**ADDENDUM NO. 10**  
 August 13, 2010

**Project:** Package A – 2010: Misc. Renovations and Additions to Cook Middle School and E.L.C. No. 2  
 Cypress-Fairbanks Independent School District

Bay Project No.:0930 (10-02-2196R-FP)

REVISED ROOF EDGE DETAILS 26 & 27/A6.02-co

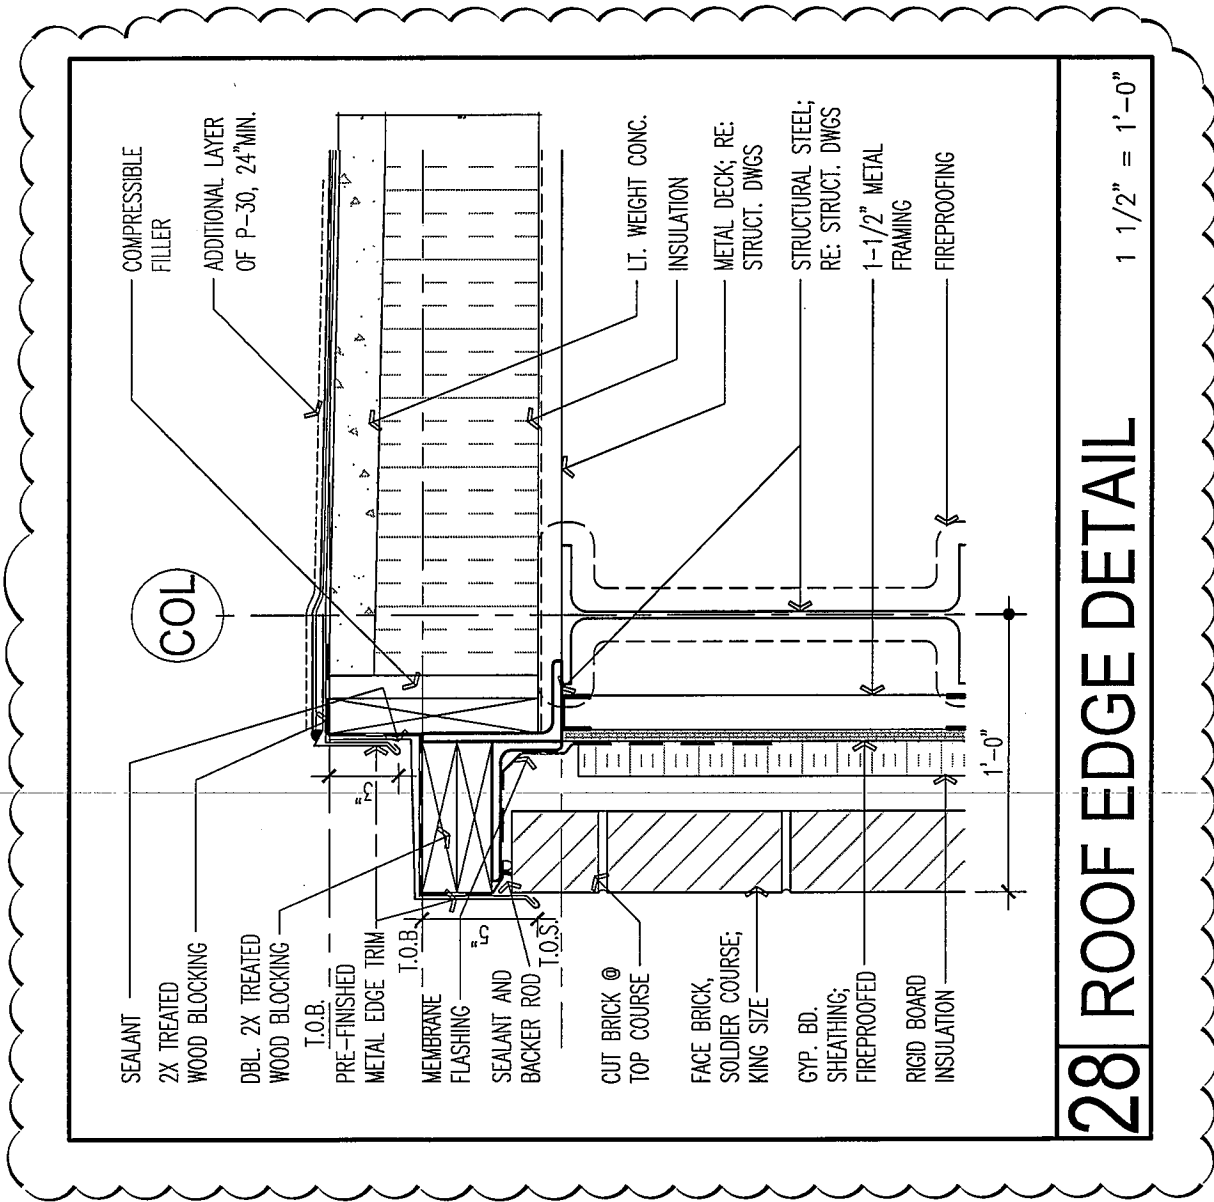
- a. Revise Details 26 & 27/A6.02-co and 28/A6.02-co ROOF EDGE DETAILS per attached sketches SK-ADD10-01 and SK-ADD10-02, respectively. Delete any reference to 26' and 27'.
